**Draft Marine Aggregate Regional Environmental Assessment of the Anglian Offshore Region as at July 2011.**

**Original report produced by EMU Ltd on behalf of Anglian Offshore Dredging Association.**

Summary of comments received on the above report from: **Cefas, JNCC, Natural England, English Heritage**

**Figure 1** - Area 202 swath bathymetric survey in 2009. Note the linear feature of the active dredging area not impacting on the dynamics of the bank.

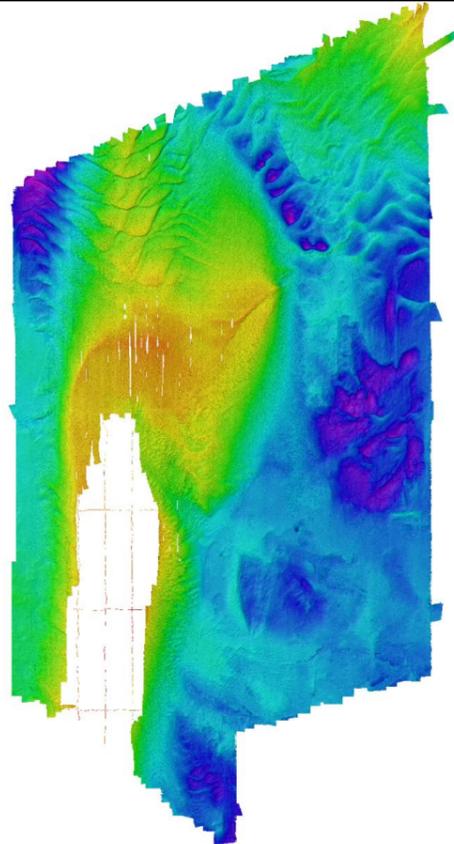
Discussion should be provided on the confidence in the spatial area of the banks. It is known that in these dynamic areas the location and shape of the inshore banks change over time. What dataset was used to spatially define the inshore banks and can this be confirmed by available local monitoring data? Understanding the confidence is required as it relates to the spatial extent of impacts and potential for interaction between receptors and effects.

In relation to the discussion on the plume model results the interaction between multiple dredgers in adjacent areas should be undertaken (i.e. it is understood that in this region up to 4 dredgers can be working in a relatively close area at the same time).

The resolution of the figures makes it particularly difficult to review the scale of effects. In this region the impacts are demonstrated to be relatively small, but as the receptors are close to the dredging areas, a detailed integration of the spatial extent is required – currently this cannot be achieved with the figures provided. I recommend that all the data presented should also be provided in GIS format to allow for a detailed look at where the overlap is with potential sensitive receptors, especially in Area 202 for example.

Greater use should be made of existing monitoring reports, especially 100% swath bathymetry surveys, which give a good indication of changes in sediment transport patterns and pathways.

The most recent SeaZone Hydrosatial data was utilised, down to a depth of 15 m below sea level. This is probably the best regional bathymetry dataset that is currently and publicly available.

Any areas of overlap which currently are not clear will be expanded and produced in higher resolution in the final document (e.g. using inset figures). GIS data can be requested from AODA.

Seazone data includes available high resolution multibeam data – however, since this is a regional assessment, site-specific monitoring survey results are beyond the scope of this project but need to be considered within licence-specific assessments. We presume the East Coast REC provides additional detailed information on sandbanks and seabed morphology/evolution – if so; some of the results/outputs can be incorporated into the REA.

The final figures will clearly show any overlap with changes in effects and sensitive receptors such as Sandbanks. GIS data can be requested directly from AODA. The sensitivity of sandbanks and magnitude of change of effects which may impact sandbanks has been discussed in detail in Chapter 19.

Area 202 monitoring has been included in Box 2 of Chapter 19.
